Subject: BDCP Draft EIR/EIS

Chapter 9, Geology and Seismicity, Section 9.3.3.9, Impact GEO-3, beginning p. 9-181

Impact GEO-3: Loss of Property, Personal Injury, or Death from Ground Settlement during Construction of Water Conveyance Features (Note: Impact GEO-3 applies at all tunnel alternatives; Section 9.3.3.9 refers to Alternative 4, the preferred alternative)

From the *Technical Design Manual for Design and Construction of Road Tunnels* (US Department of Transportation, Federal Highway Administration), Figure 7-9.

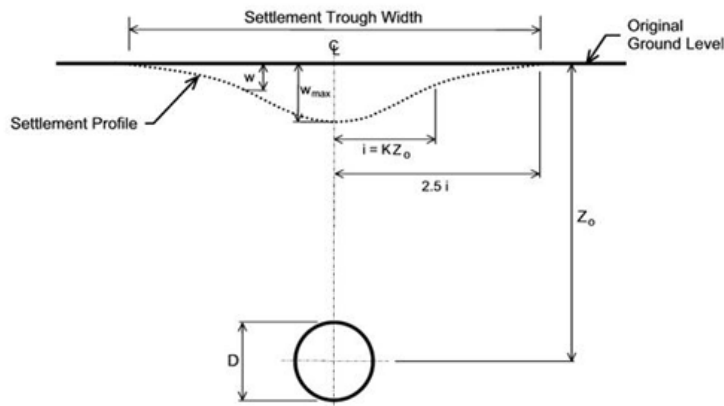
According to US Department of Transportation, Federal Highway Administration, *Technical Design Manual for Design and Construction of Road Tunnels*, and *A Method of Estimating Surface Settlement Above Tunnels Constructed in Soft Ground*, by R.K Rowe and K.Y. Lo (National Research Council of Canada, 1983) and *Predicting the Settlements Above Twin Tunnels Constructed in Soft Ground* by D. N. Chapman, C.D.F. Rogers and D.V.L. Hunt, University of Birmingham, U.K., estimating potential ground settlement above tunnels in soft ground can be accomplished with accepted mathematical formulas. However, in the EIS all methods to estimate potential ground settlement above the twin tunnels are ignored.

The risk of ground settlement to cause personal injury above the tunnels may be low. However, the EIS ignores the potential for adverse impacts at the ground surface based on accepted soil mechanics applications. The *Technical Design Manual for Design and Construction of Road Tunnels* (US Department of Transportation, Federal Highway Administration) provides an approach to estimate ground surface settlement impacts above tunnels. Based on the design manual's mathematical formulas numbers 7-2, 7-3 and 7-4, it is possible to estimate the width and depth of a settlement trough. The design manual also states that, "In the case of parallel adjacent tunnels, surface settlement is generally assumed to be additive."

Therefore, based on published data, accepted soil mechanic applications and the proposed BDCP tunnel geometry, known or estimated groundwater conditions and soil types as stated in other chapters of the BDCP EIS, a reasonable estimate of ground surface settlement can be determined. The BDCP EIS should be revised to include such an estimate to be used to evaluate surface impacts so that an informed reviewer can understand the surface settlement effects of the twin tunnels.
